**WATTS BAR NUCLEAR PLANT (WBN) UNIT 1 - SECOND 10-YEAR  
INSERVICE TESTING INTERVAL - REQUEST FOR ADDITIONAL  
INFORMATION (RAI) CONCERNING RELIEF REQUEST PV-02 (TAC NOS.  
MD2527, MD2528, MD2529, MD2530)**

### WATTS BAR NUCLEAR PLANT (WBN) UNIT 1 SECOND 10-YEAR INSERVICE TESTING INTERVAL RELIEF REQUEST PV-02 REQUEST FOR ADDITIONAL INFORMATION (RAI)

**Tennessee Valley Authority  
Watts Bar Nuclear Plant, Unit 1  
Second 10-Year Interval  
Request for Relief Number PV-02**

WATTS BAR NUCLEAR PLANT (WBN) UNIT 1  
SECOND 10-YEAR INSERVICE TESTING INTERVAL  
PHOTOGRAPH AND MECHANICAL DRAWING OF  
ERCW SCREEN WASH PUMP DISCHARGE PIPING

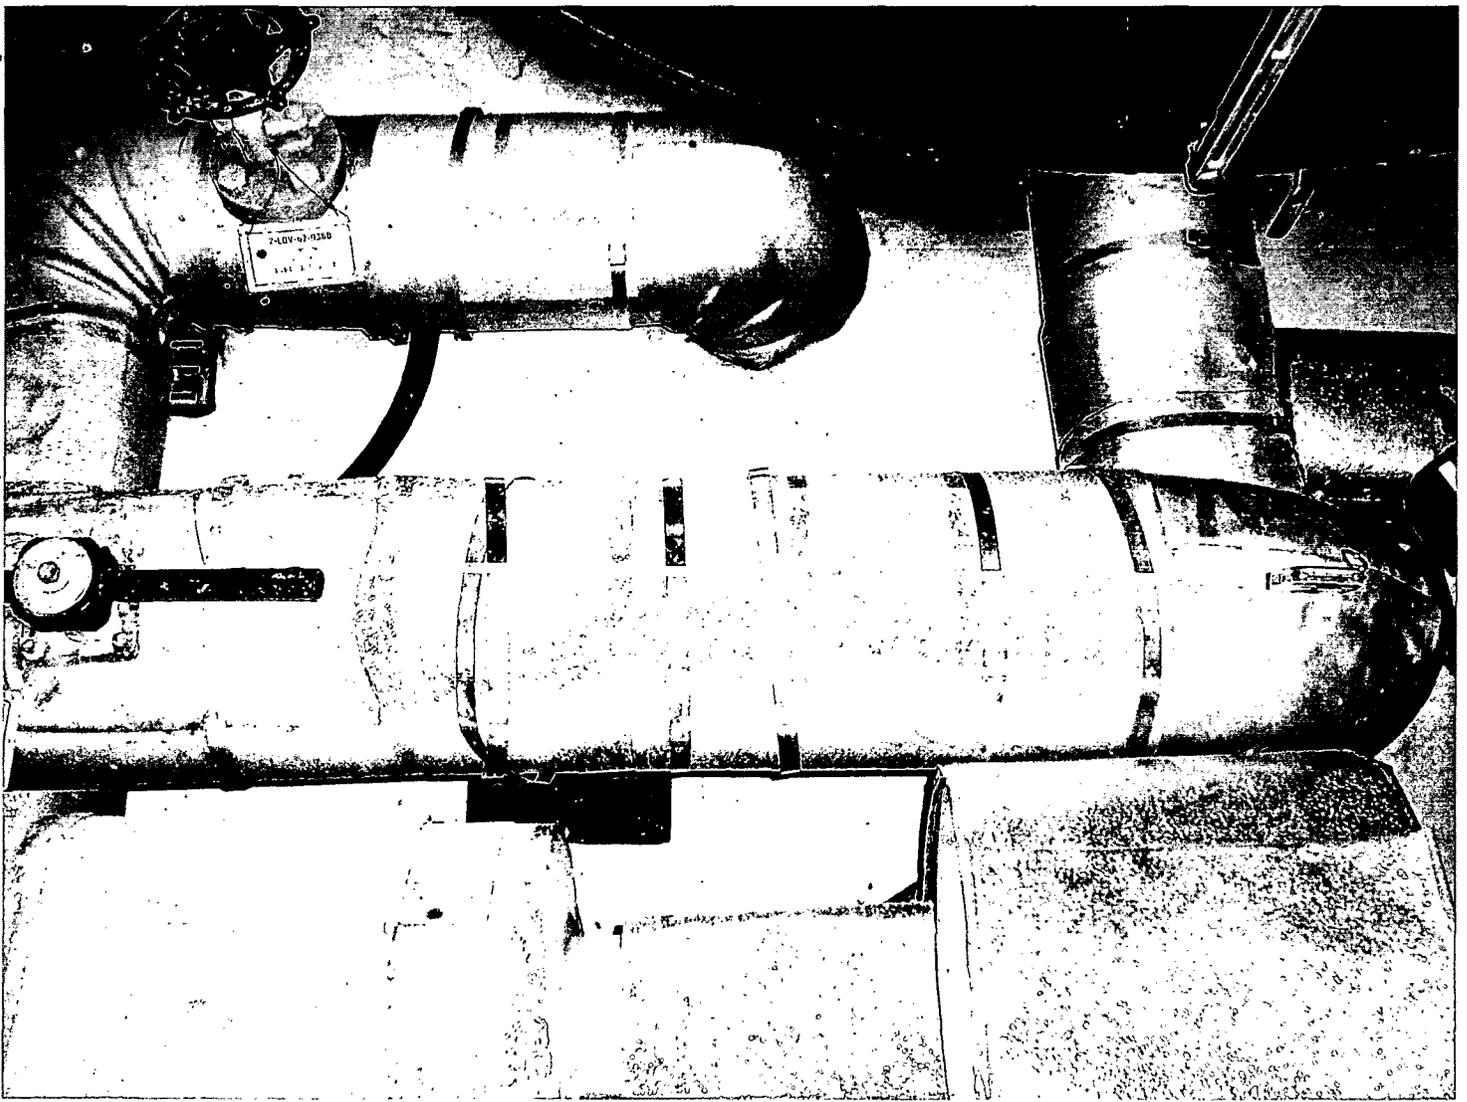
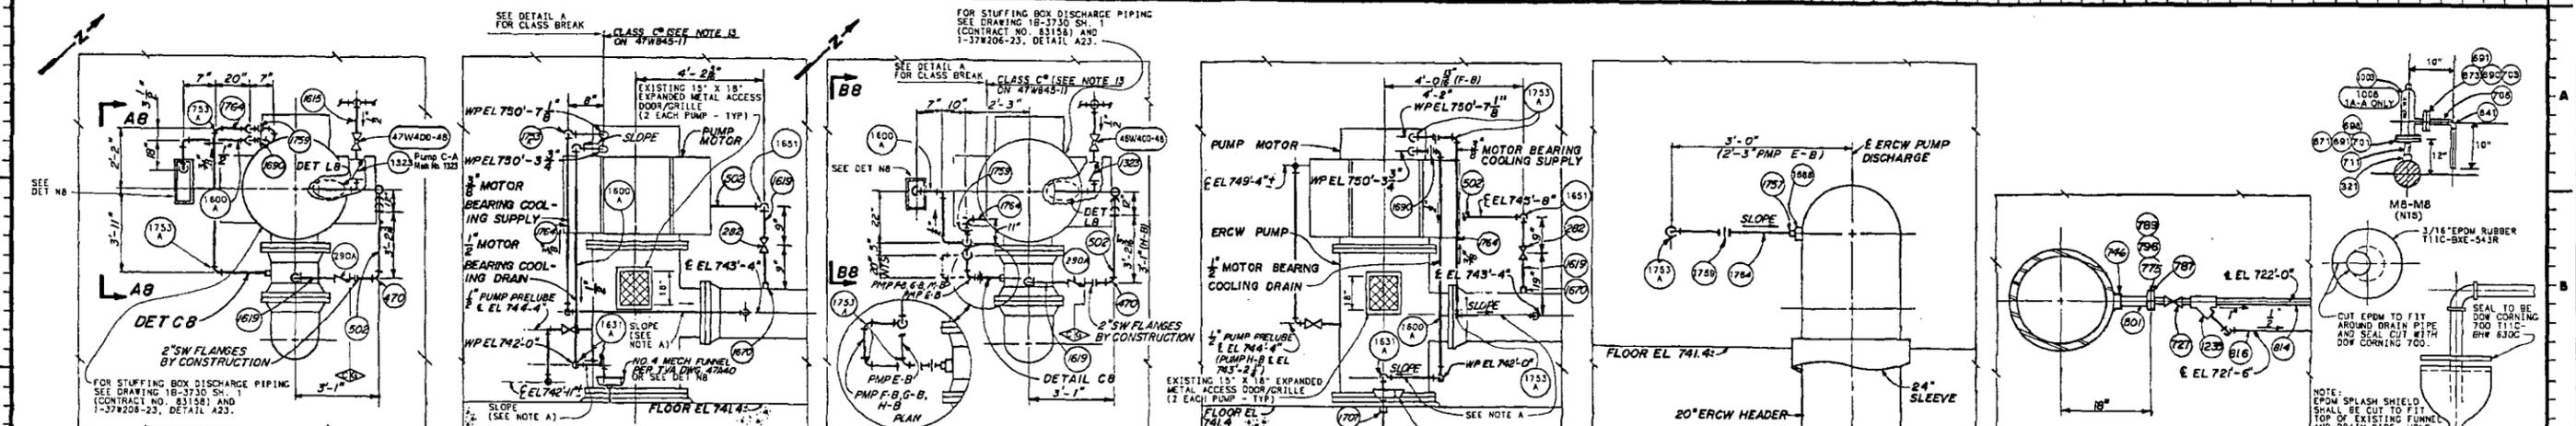
*The relief request states that the physical configuration of this piping is such that no portion of the piping meets the requirements for adequate installation of a permanent flow measuring device. Please provide additional information with regard to the feasibility of installing flow instrumentation or using temporary flow instrumentation (i.e., modifications required, detailed description of piping runs with respect to installation of temporary flow instrumentation). Please discuss in greater detail the feasibility of installing temporary flow instrumentation during the comprehensive pump test.*

Photographs and a Mechanical Intake Pumping Station Piping and Equipment drawing of the screen wash pump system (See Section D-8) are provided in Enclosure 3 to show the piping configuration. TVA has determined that a significant plant modification would be required to install flow instruments for this system. A plant modification would include rerouting three-inch diameter piping and the associated piping supports for four pumps.

The feasibility of installing temporary flow instrumentation was considered by TVA for utilizing portable ultrasonic flow instrumentation during testing. Accurate and repeatable flow measurement requires the ultrasonic flow sensor to be positioned on straight runs of piping (preferably horizontal). The standard recommendation for flow measuring devices requires placement of the measurement point ten pipe diameters distance upstream and five pipe diameters distance downstream to allow for straight undisturbed flow stream for accurate flow measurement. This requires a minimal run of piping of 45-inches in length. The current system piping configuration has no sections that provides the necessary configuration or that could be easily modified. The longest run of piping is 36-inches in length. Therefore, TVA has determined that a significant plant modification would be required to install temporary flow instruments for this system.
